**CITY OF SAUSALITO**  
420 Litho Street, Sausalito, CA 94965

**Addendum No. 3**

Issued **July 17, 2020**

**For**  
**2020 Sausalito Streets Rehabilitation Project**  
**Bee Street and Bonita Street**

- a. For a and b, See Revised Detail 9/CD01 below.

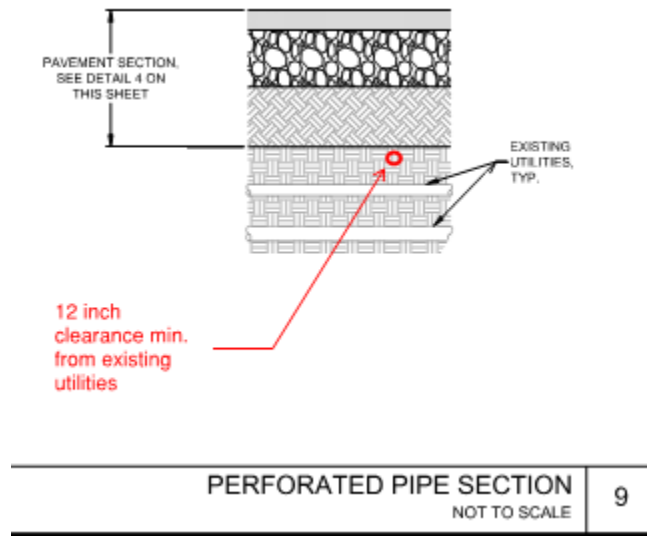
- a. There is no trench detail for the perforated subdrain pipe? Only detail 9/CD01 showing it 12" under the deepest utility. Appears that contractor is to place a perforated pipe at approximately 6' deep with native backfill. Please provide detail?
- b. Please provide invert/rim elevations or profiles for the new and perforated storm drain. Detail 9 on CD-01 does not provide this information. Depth varies???

- a. See details below for limits of work associated with ramps based on detail 2 Sheet CD.01.

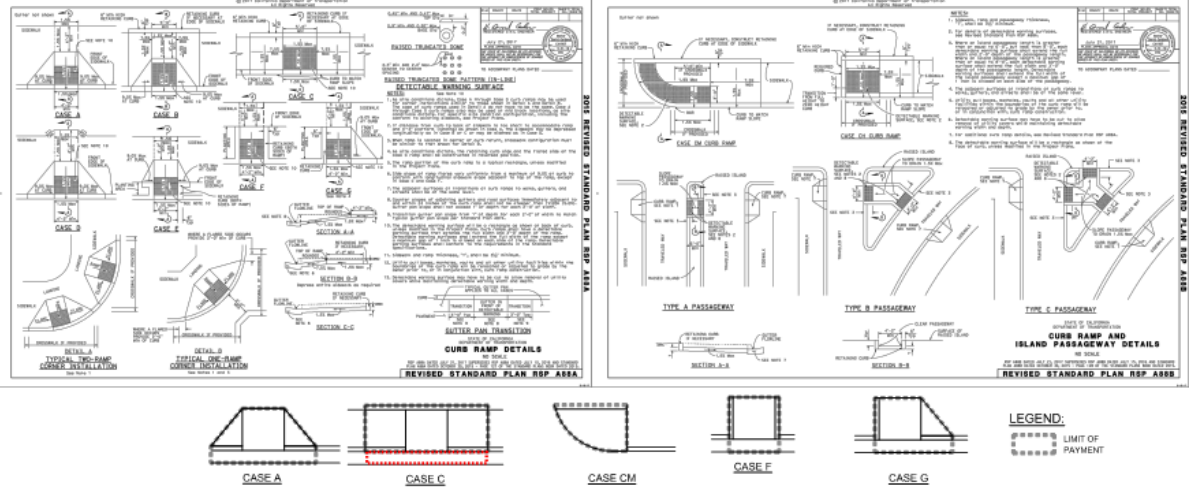
- a. Bonita and Bee - The handicapped ramps will be paid based upon the square footing of handicapped ramps, installed. Is this unit price to include the construction of the curb and gutter in front of the ramp?
- b. Bee – Is the city curb and gutter in front of the driveway approach to be included in the pricing for the driveway or should it be included in the curb and gutter pay item?

- b. The curb and gutter along Bee will be replaced with this project and should be included in the price for removal and replacement of curb and gutter along Bee Street.
- c. See image below associated with Sheet CR.03.

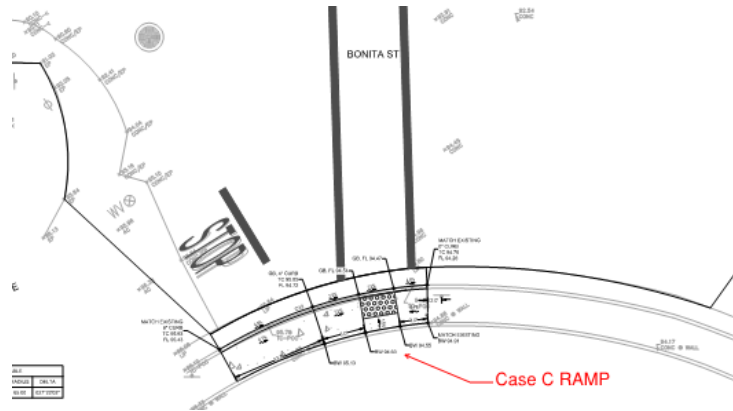
- c. Bee – Bid Item 2d – Case C handicapped ramp. Where is this ramp located?
